Form # P 04 DISPLAY THIS CA Please Read Application And Notes, If Any, Attached	ARD ON PRINCIPAL FRO	
This is to certify that <u>NGUYEN TIENG C & H</u>	HE HI NGUYEN JTS	
has permission to interior renovations & rep	pair lace from no recepts	
AT 284 BRACKETT ST	(0e	53 1003001
provided that the person or person of the provisions of the Statutes of the construction, maintenance and this department. Apply to Public Works for street line and grade if nature of work requires such information.	of the and of the chances	ng this permit shall comply with all s of the City of Portland regulating es, and of the application on file in A certificate of occupancy must be procured by owner before this build- ing or part thereof is occupied.
OTHER REQUIRED APPROVALS Fire Dept Health Dept Appeal Board Other Department Name		Diregor - Building & Inspection Services
PE	NALTY FOR REMOVING THIS CA	ARD

284 BRACKETT ST NGUYEN TIENG C & HIEP THI 284 BRACKETT ST Business Name: Contractor Name: Contractor Address:	City of Portland, Maine - Buil 389 Congress Street, 04101 Tel: (2	0		4-8716	Permit No: 07-0560	Date Applied For: 05/17/2007	CBL: 063 I003001	
Business Name: Contractor Name: Contractor Name: Contr

4x4 solid wood post with a decorative finial

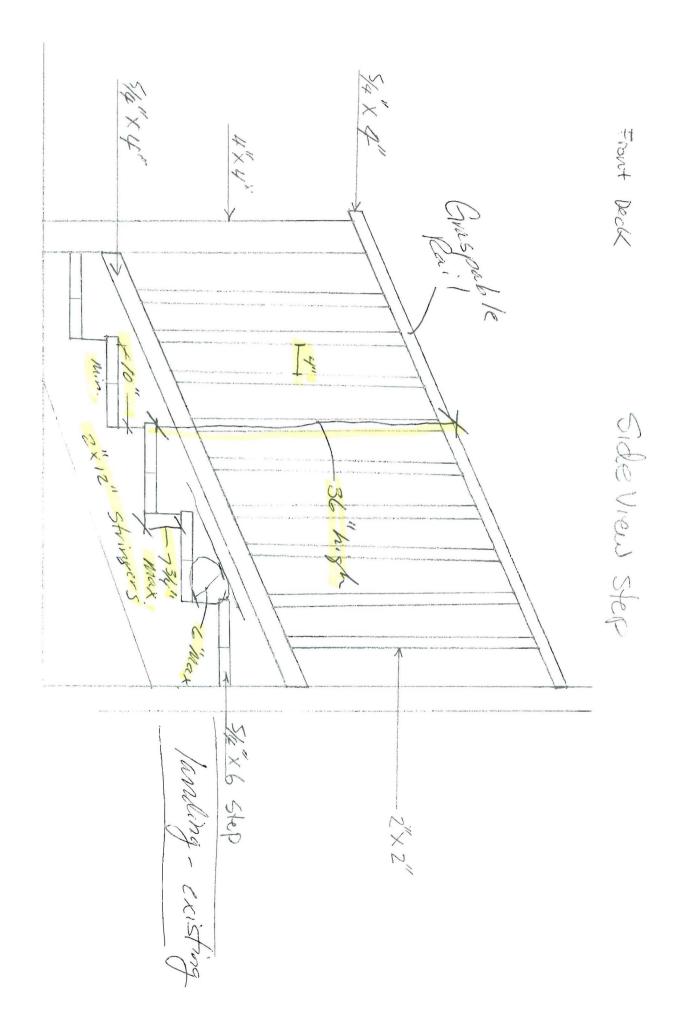
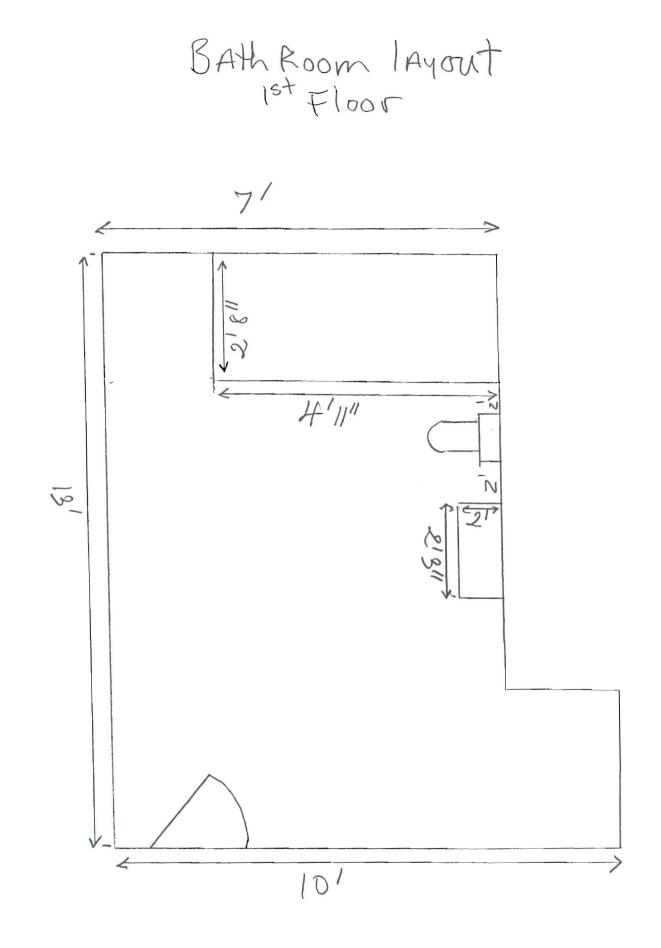
Porch and stair details to follow designs in City of Portland Porch Repair booklet as agreed by applicant on 6/5/07. Copies attached. Front and rear porches on west side of building to use either turned Queen or square with trend finial for newel post. I 1/2" x 1 1/2" square balusters. Spaced board skirting with finish 1 x 6 or 1 x 8 framing boards. Pressure treated may be used for framing only, all finish wood to be cedar or pine, painted. Composite material may be used for the newel post, and painted to match. Cornice return to be rebuilt on rear corner. Dept: Zoning Status: Approved with Conditions Reviewer: Ann Machado Approval Date: 05/25/2007 Note: Routed to historic for review Scott H Ok to Issue: This permit is being approved on the condition that the work on the two entry decks takes place within the existing foot print of the building. This permit is being approved on the basis of plans submitted. Any deviations shall require a separate approval before starting that work. ANY exterior work requires a separate review and approval thru Historic Preservation. This property is located within an Historic District. This property shall remain a two family dwelling. Any change of use shall require a separate permit application for review and approval. Dept: Building Status: Approved with Conditions Reviewer: Tammy Munson Approval Date: 10/15/2007 Note: 7/5/07 gave to Tammy for review after speaking with the owner, needs to schedule a meeting for more Ok to Issue: Permit approved based on the plans submitted and reviewed w/owner/contractor, with additional information as agreed on and as noted on plans. All penetrations between dwelling units and dwelling units and common areas shall be protected with approved firestop materials, and recessed lighting/vent fixtures shall not reduce the (1 hour) required rating. Hardwired interconnected batery backup smoke detectors sh	Dept: Historic Status: A	pproved with Condition	ns Rev	viewer	: Scott Hanson	Approval Da	nte: 06/05/2007

attached. Front and rear porches on west side of building to use either turned Queen or square with trined finial for newel post. 1 1/2" s under balusters. Spaced board skirting with finish 1 x 6 or 1 x 8 framing boards. Pressure treated may be used for framing only, all finish wood to be cedar or pine, painted. Composite material may be used for the newel post, and painted to match. 2) Cornice return to be rebuilt on rear corner. Dept: Zoning Status: Approved with Conditions Reviewer: Ann Machado Approval Date: 05/25/2007 Note: Routed to historic for review Scott H Ok to Issue: ✓ 1) This permit is being approved on the condition that the work on the two entry decks takes place within the existing foot print of the building. 2) This permit is being approved on the basis of plans submitted. Any deviations shall require a separate approval before starting that work. 3) ANY exterior work requires a separate review and approval thru Historic Preservation. This property is located within an Historic District. 4) This property shall remain a two family dwelling. Any change of use shall require a separate permit application for review and approval. Dept: Building Status: Approved with Conditions Reviewer: Tammy Munson Approval Date: 10/15/2007 Note: 7/5/07 gave to Tammy for review after speaking with the owner, needs to schedule a meeting for more Ok to Issue: ✓ details. 1) Permit approved based on the plans submitted and reviewed w/owner/contractor, with additional information as agreed on and as noted on plans. 2) All penetrations between dwelling units and dwelling units and common areas shall be protected with approved firestop materials, and recessed lighting/vent fixtures shall not reduce the (1 hour) required rating. 3) Hardwired interconnected battery backup smoke detectors shall be installed in all bedrooms, protecting the bedrooms, and on every level. 4) Separate permits are required for any electrica	Note:						Ok to Issue: 🗸

BAth Room LAyout 2nd Floor

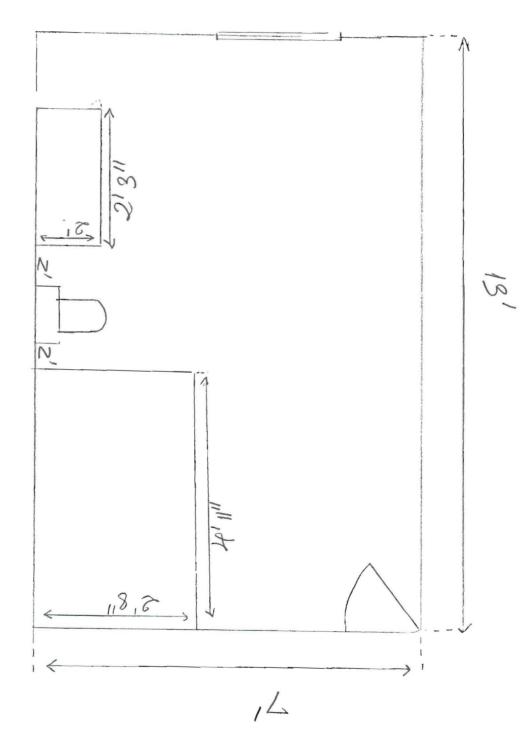
details. Permit approved based on the plans submitted and reviewed w/owner/contractor, with additional information as agreed on and as noted on plans. All penetrations between dwelling units and dwelling units and common areas shall be protected with approved firestop materials, and recessed lighting/vent fixtures shall not reduce the (1 hour) required rating. Hardwired interconnected battery backup smoke detectors shall be installed in all bedrooms, protecting the bedrooms, and on every level. Separate permits are required for any electrical, plumbing, or HVAC systems. 	Dept: Building Status: A	pproved with Conditio	ns Rev	viewer	: Tammy Munson	Approval Da	ate: 10/15/2007	
 noted on plans. 2) All penetrations between dwelling units and dwelling units and common areas shall be protected with approved firestop materials, and recessed lighting/vent fixtures shall not reduce the (1 hour) required rating. 3) Hardwired interconnected battery backup smoke detectors shall be installed in all bedrooms, protecting the bedrooms, and on every level. 4) Separate permits are required for any electrical, plumbing, or HVAC systems. 		view after speaking wit	h the own	ier, nee	eds to schedule a me	eeting for more	Ok to Issue: 🗸

and recessed lighting/vent fixtures shall not reduce the (1 hour) required rating. 3) Hardwired interconnected battery backup smoke detectors shall be installed in all bedrooms, protecting the bedrooms, and on every level. 4) Separate permits are required for any electrical, plumbing, or HVAC systems. 		ns submitted and review	ved w/ow	/ner/co	ntractor, with additi	onal information as a	greed on and as	
every level.4) Separate permits are required for any electrical, plumbing, or HVAC systems.						eted with approved f	irestop materials,	
		backup smoke detector	rs shall be	e instal	led in all bedrooms,	protecting the bedro	oms, and on
